Concerning the **PSJA ISD CARMAN ELEMENTARY SCHOOL AND SANTOS LIVAS ELEMENTARY SCHOOL PLAYGROUND IMPROVEMENTS BID # 18-19-049**, to be opened at 4:00 p.m., Tuesday, May 21, 2019. Please consider the following:

ADDENDUM # 2

PROJECT: P S J A I. S. D.
Carman Elementary School & Santos Livas
Elementary School Playground Improvements
Bid # 18-19-049

ARCHITECT: EGV Architects, Inc.
220 S. Bridge
Hidalgo, TX 78557
(956) 843-2987

AS1.1 SHEET OF 11

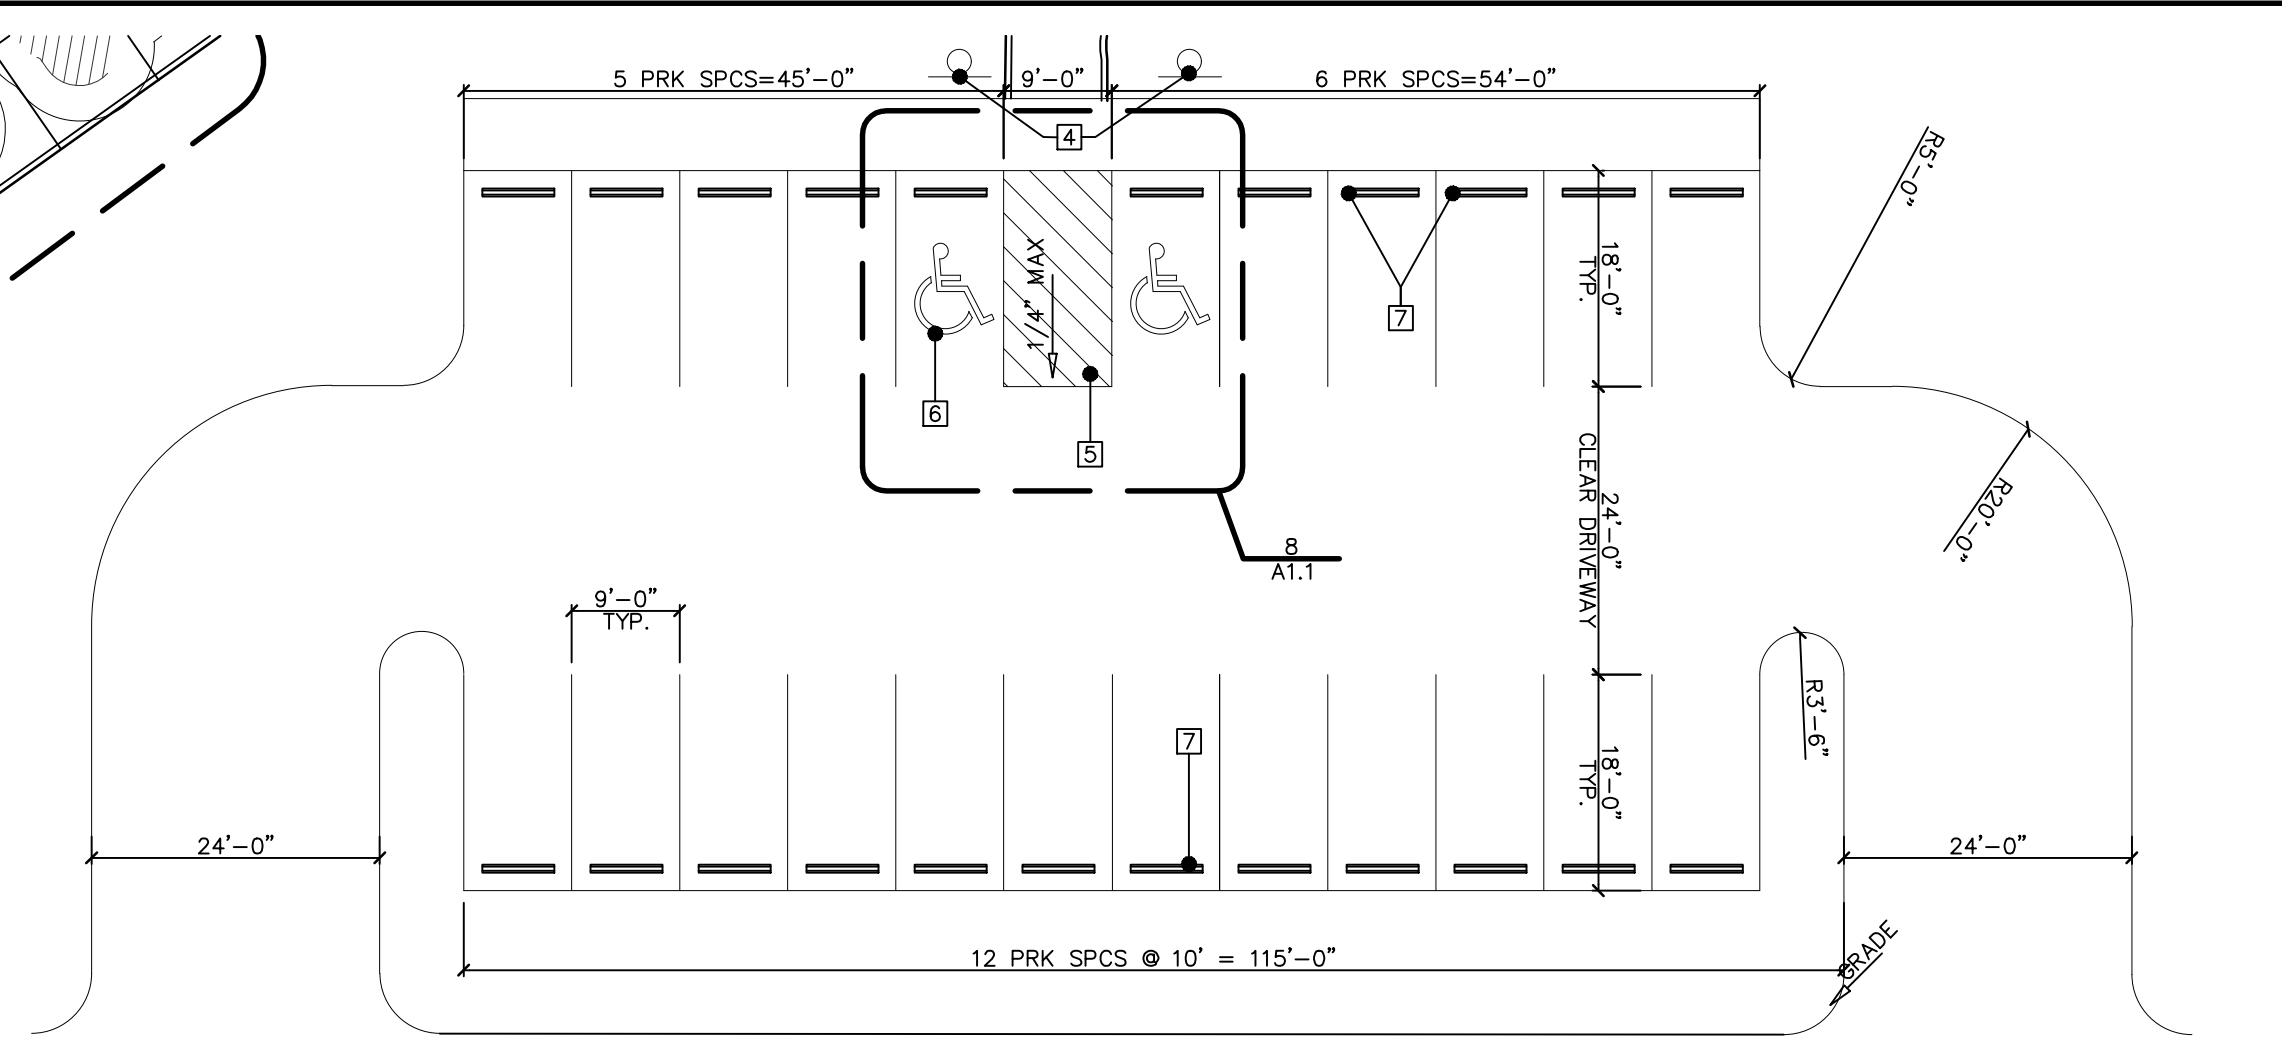
- Refer to attached drawing labeled **ATTACHMENT #3** (1 sheet) for clarification of chain link fence and deletion of Note #14 on legend. See clouded areas.

8. Santos Livas Site, on Sheet AS1.1 Legend #14 it states "New chain link fence around property see Sheet A1.01." Need clarification on fence location on property site.

- **Refer to attached drawing labeled ATTACHMENT #3 for clarification of chain link fence and deletion of Note #14 on legend. See clouded areas.**
